Proposed Code Modifications

This document created by the Florida Department of Business and Professional Regulation -
850-487-1824

TAC: Energy

Sub Code: Energy Conservation

FIGURE C405.2.3.3
~~DAYLIGHT ZONE UNDER A ROOF FENESTRATION ASSEMBLY~~

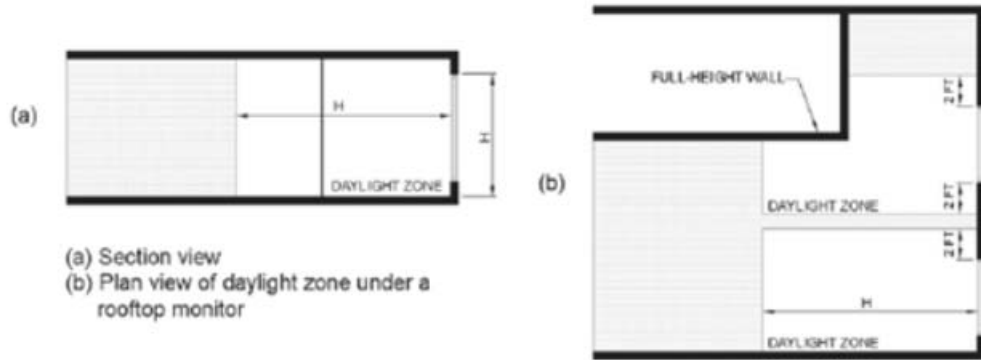
1. The ~~daylight~~ toplit zone shall extend laterally and longitudinally beyond the edge of the roof fenestration assembly to the nearest obstruction that is taller than 0.7 times the ceiling height, or up to 0.7 times the ceiling height, whichever is less, as indicated in Figure C405.2.3.3(1).

3. ~~Where located in existing buildings, the~~ 4. The product of the visible transmittance of the roof fenestration assembly and the area of the rough opening of the roof fenestration assembly divided by the area of the daylight toplit zone is not less than 0.008.

FIGURE C405.2.3.2
 SIDELIT ZONE

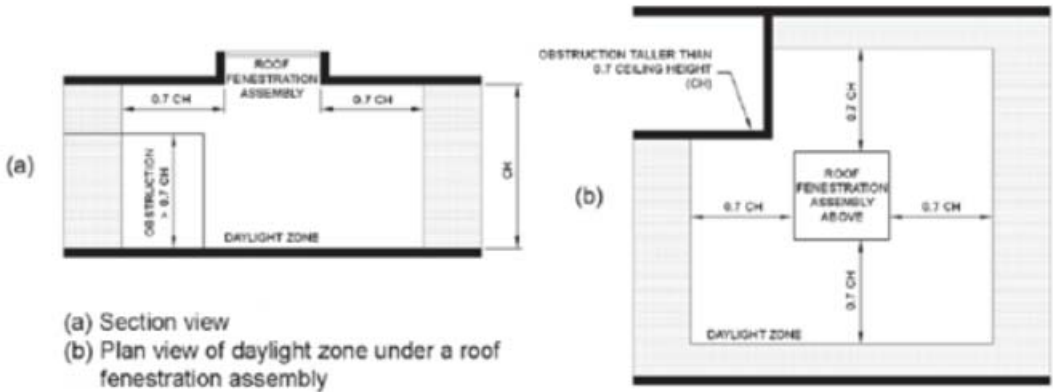
1. Where the fenestration is located in a wall, the ~~daylight~~ sidelit zone shall extend laterally to the nearest full-height wall, or up to 1.0 times the height from the floor to the top of the fenestration, and longitudinally from the edge of the fenestration to the nearest full-height wall, or up to 2 feet (610 mm), whichever is less, as indicated in Figure C405.2.3.2(4).
